WESTMINSTER ESTATES SUBDIVISION, **RESUBDIVISION OF LOT 24**

APPLICATION NUMBER 8 DATE December 15, 2016
APPLICANT Westminister Estates Subdivision, Resubdivision of Lot 24
REQUEST Subdivision

DETAIL SITE PLAN

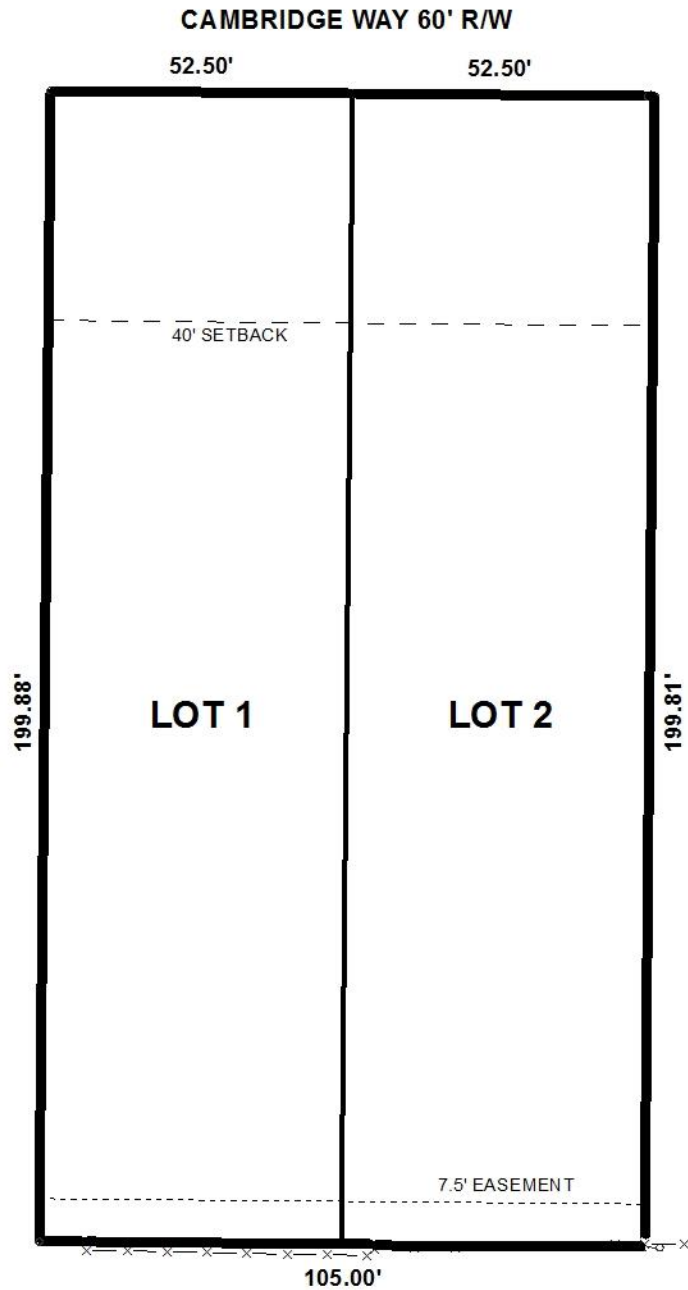
The lots have frontage along Cambridge Way, a minor street without curb and gutter requiring a 60' right-of-way width. The plat illustrates dedication sufficient right-of-way; therefore, no additional dedication should be required.

The lots, as proposed, would be substandard in width, each being only 52.5' wide; however, Magnolia Village, a 74-lot subdivision directly south of the subject site, is composed of lots substandard in width and was approved at the October 21, 1999 meeting of the Planning Commission. However, while Magnolia Village consists entirely of substandard lots with reduced setbacks, Westminster Estates consists entirely of lots more than 70' in width with standard setbacks; as such, the proposed subdivision is out of character with the parent subdivision.

Also, it should be noted that the proposed lots exceed the maximum width-to-depth ratio of Section V.D.3. of the Subdivision Regulations. If approved, a waiver of Section V.D.3. would be required.

In addition to being substandard in width, the proposed lots do not meet the minimum area requirements of the Subdivision Regulations for lots with a public water supply and individual septic systems. Each lot will be approximately 10,490 s.f., but Section V.D.2. of the Subdivision Regulations requires the lots to be a minimum of 15,000 s.f., each.

With regards to access management, a note should be placed on the Final Plat, if approved, stating each lot is limited to one curb cut to Cambridge Way, with any changes in their sizes, locations, or designs to be approved by County Engineering and conform to AASHTO standards.

The Subdivision Regulations require a 25' minimum building setback line to be illustrated on the plat; however, a 40' minimum building setback line is illustrated. If the applicant chooses to maintain a 40' minimum building setback line, this information should be retained on the Final Plat, if approved; otherwise, a 25' minimum building setback line should be illustrated.

A 7.5' drainage and utility easement is illustrated in the rear of each lot. As such, if approved, a note should be placed on the Final Plat stating no structures will be constructed in any easement.

- 1) the proposed lots do not meet minimum lot width requirement of Section V.D.1. of the Subdivision Regulations;
- 2) the proposed lots do not meet the minimum 15,000 s.f. requirement of Section V.D.2. of the Subdivision Regulations;
- 3) the proposed lots exceed the width-to-depth ratio limitation of Section V.D.3. of the Subdivision Regulations; and,
- 4) the proposed lots would be out of character with the parent subdivision.
